Summary of Comments on Serial Attached SCSI 1.1 (SAS-1.1) Standard

3.1.35 cumulative distribution function (CDF):

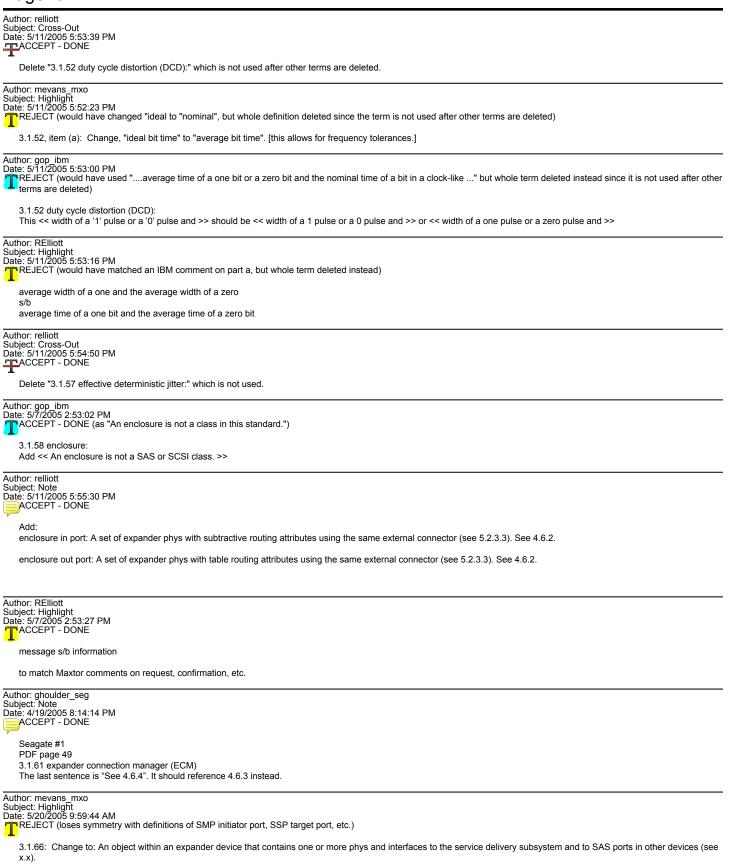
This may not be the correct definition - even as it applies to jitter measurements. It is not cumulative over time, but rather cumulative over a population of jitter measurement samples. Jitter samples are measured as intervals of time, but this definition sounds like it's based on absolute time, not sampled intervals. Suggest:

"The integral of the PDF (see 3.1.143) <with limits from> negative infinity to a specified

Author: rlsheffi_intc Subject: Highlight Date: 5/20/2005 9:56:11 AM TACCEPT - DONE ("The probability that jitter is less than a given value. See MJSQ.")

3.1.100 jitter, data dependent (DDJ):

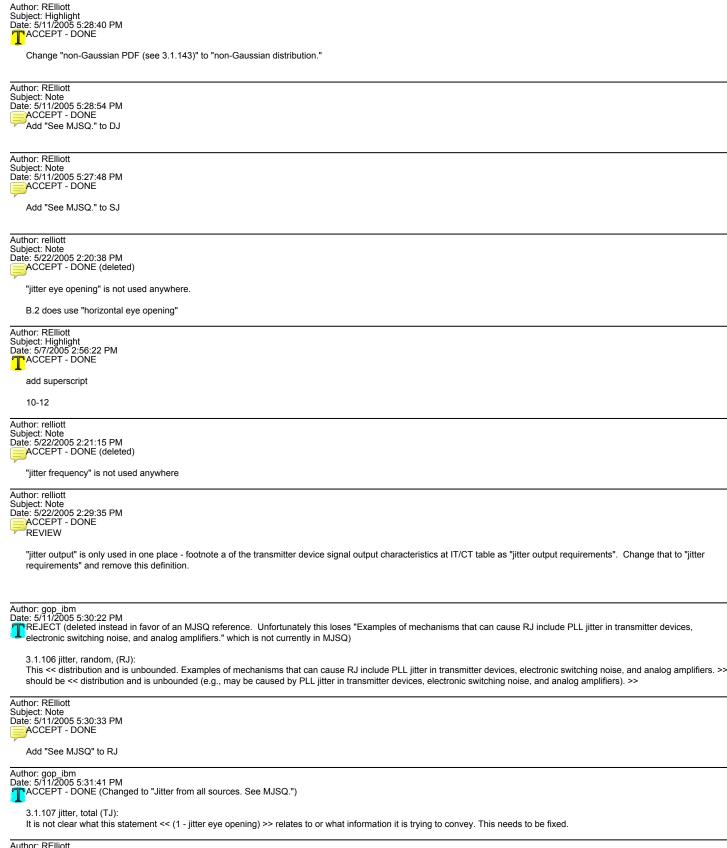
This << For example, when using media that attenuates the peak amplitude of the bit sequence consisting of repeating 0101b patterns more than peak amplitude of the bit sequence consisting of repeating 00001111b patterns, the time required to reach the receiver threshold with the 0101b patterns is less than required from the 00001111b patterns. The run length of 4 produces a higher amplitude that takes more time to overcome when changing bit values and therefore produces a time difference compared to the run length of 1 bit sequence. >> should be << (e.g., when using media that attenuates the peak amplitude of the bit sequence consisting of repeating 0101b patterns more than peak amplitude of the bit sequence consisting of repeating 00001111b patterns, the time required to reach the receiver threshold with the 0101b patterns is less than required from the 00001111b patterns. The run length of four produces a higher amplitude that takes more time to overcome when changing bit values and therefore produces a time difference compared to the run length of one bit sequence). >>

Author: gop_ibm Date: 5/11/2005 5:26:33 PM CEPT - DONE (refer to MJSQ instead)

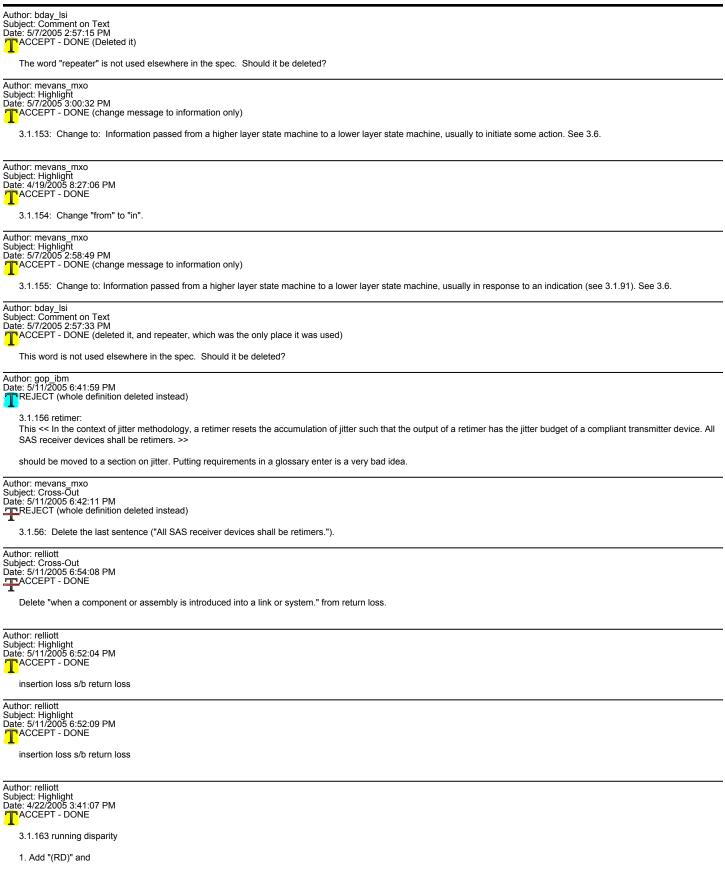
Add "3.1.xx OOB interval: The time basis for burst times (see 3.1.18) and idle times (see 3.1.90) used to create OOB signals (see 3.1.131). See 6.6.1."

This supports the OOBI acronym added per a Seagate comment.

Figure 9 - State machine conventions

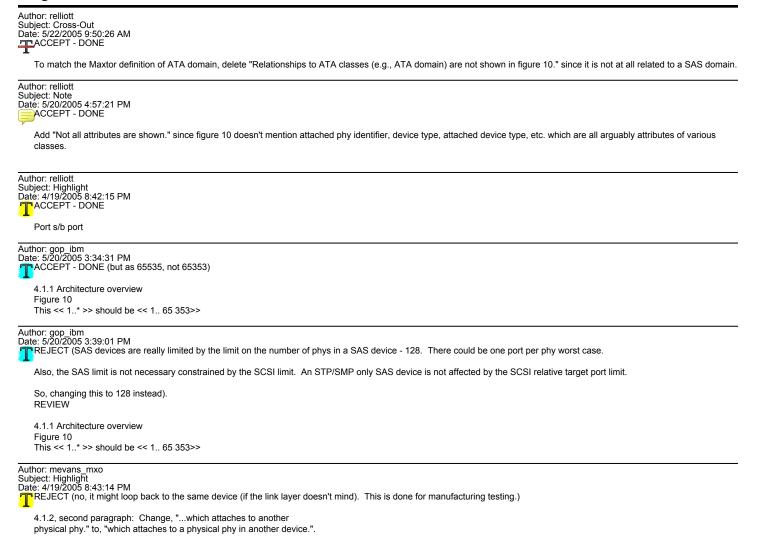
Many of the state machines in the standard contain only a single state. When the State designator:State_Name format is used, the text never references this state, and a search for this State designator:State_Name would only hit the state machine state on the figure.

I propose that for state machines that only have a single state, that the state name be left off and a sentence that follows be added to the paragraph after Figure 9. "For state machines that only contain a single state, only the state designator may be used."

4.4.2 Hard reset

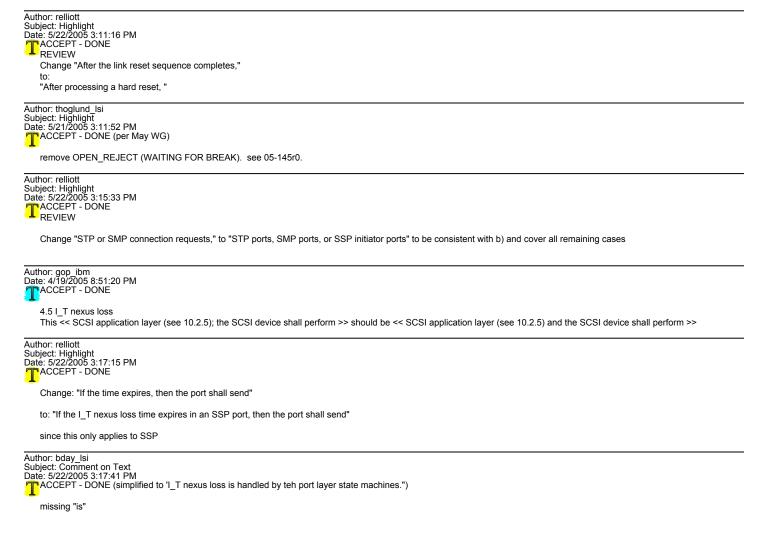
Clarify what "hard reset" means or does not mean in an expander. This still causes confusion.

ACCEPT - DONE (Split 4.4.2 Hard reset into 3 subsections - overview, Additional hard reset processing by SAS ports, and Additional hard reset processing by expander ports. See comments on individual paragraphs for specific wording changes.)

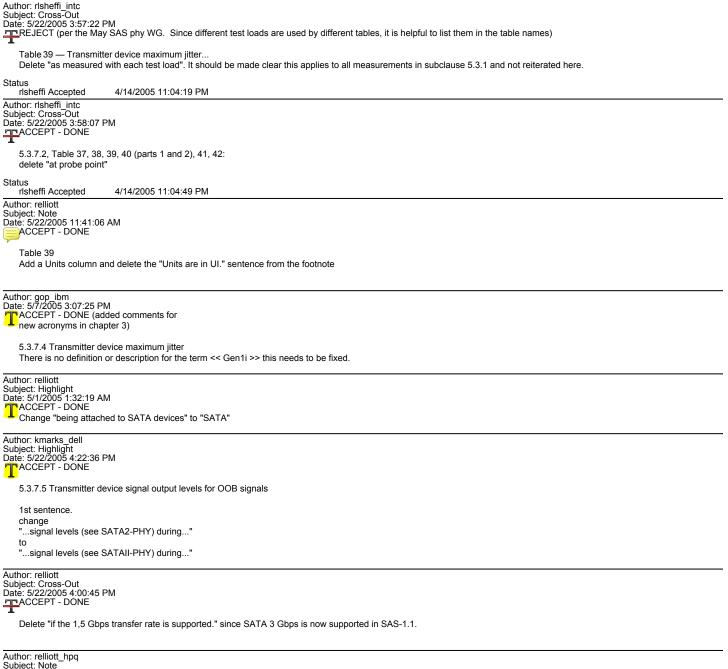
Autnor: boissone_mic Subject: Comment on Text Date: 5/22/2005 3:57:19 PM ACCEPT - DONE (Agree that since SATA II doesn't allow 3 Gbps ALIGNs, then a SAS phy supporting attachment to SATA devices must not be allowed to transmit them. This ACCEPT - DONE (Agree that since SATA II doesn't allow 3 Gbps ALIGNs, then a SAS phy supporting attachment to SATA devices must not be allowed to transmit them. This ACCEPT - DONE (Agree that since SATA II doesn't allow 3 Gbps ALIGNs, then a SAS phy supporting attachment to SATA devices must not be allowed to transmit them. This ACCEPT - DONE (Agree that since SATA II doesn't allow 3 Gbps ALIGNs, then a SAS phy supporting attachment to SATA devices must not be allowed to transmit them. This

Also, a SAS phy would never transmit D24.3 characters since that breaks its SAS rule (we assume that SAS never discusses phys that ONLY attach to SATA). So, D24.3 also needs to be removed.

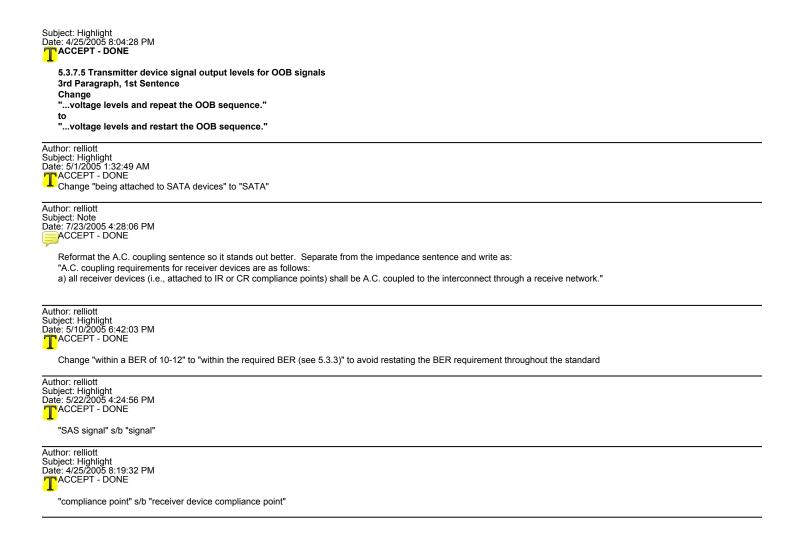
Section reworded as:

Transmitter devices supporting SATA shall use SATA Gen1i or Gen2i signal levels (see SATAII-PHY) during the first OOB sequence (see 6.7) after a power on or hard reset. If the phy does not receive COMINIT within a hot-plug timeout (see 6.7.5), the transmitter device shall increase its transmit levels to the SAS signal levels specified in table 45 (see 5.3.6) and table 46 (see 5.3.6.3) and perform the OOB sequence again. If no COMINIT is received within a hot-plug timeout of the second OOB sequence, the transmitter device shall initiate another OOB sequence using SATA Gen1i or Gen 2i signal levels. The transmitter device shall continue alternating between transmitting COMINIT using SATA Gen1i or Gen 2i signal levels and transmitting COMINIT with SAS signal levels until the phy receives COMINIT.

If the phy both transmits and receives COMSAS (i.e., a SAS phy or expander phy is attached), the transmitter device shall set its transmit levels to the SAS signal levels. If it had been using SATA Gen1i or Gen2i signal levels, this mode transition (i.e., output voltage change) may result in a transient (see 5.3.4) during the idle time between COMSAS and the SAS speed negotiation sequence (see 6.7.4.2).

If the transmitter device is using SAS signal levels and the phy does not receive COMSAS (i.e., a SATA phy is attached), the transmitter device shall set its transmit levels to the SATA Gen1i or Gen 2i signal levels and restart the OOB sequence.

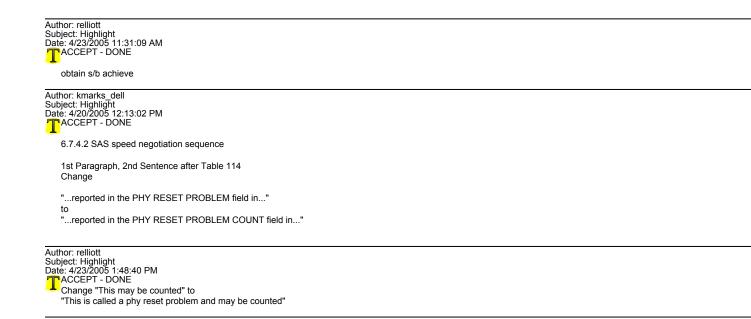
> Figure 114 - redraw so RCD looks a bit more to scale. Also show the link layer dwords starting at the end of the sequence - current picture is sometimes misinterpreted as meaning "go back to D.C. idle"

9.2.2.2 TASK information unit

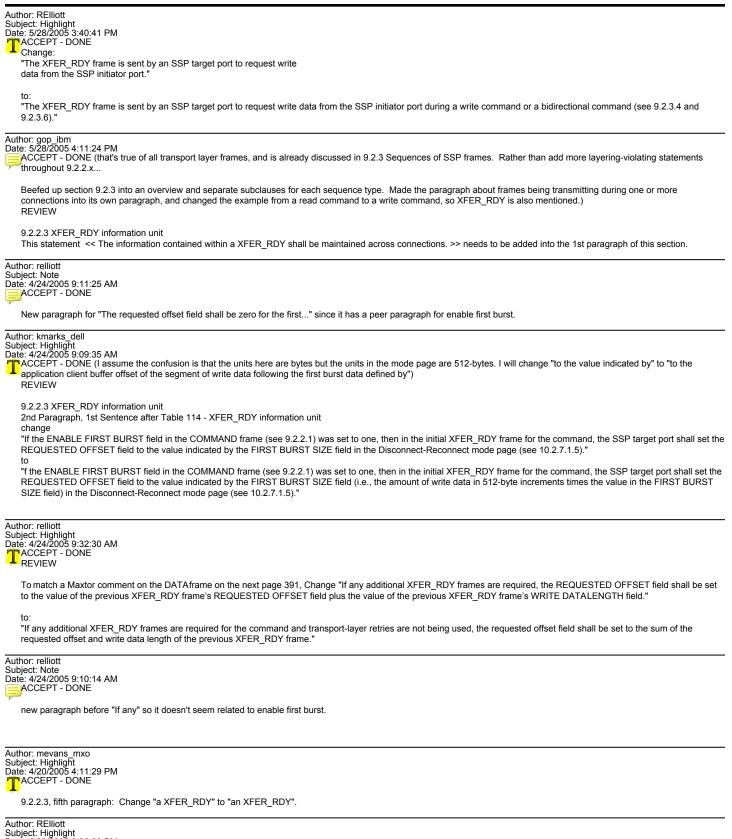
This << The TARGET RESET task management function defined in SAM-3 is not supported. >> is not correct as SAAM-3 does not define target reset. SAM-2 does. I think this should be deleted rather than adding a reference to SAM-2.

Author: gop_ibm Date: 5/21/2005 9:18:05 PM TACCEPT - DONE
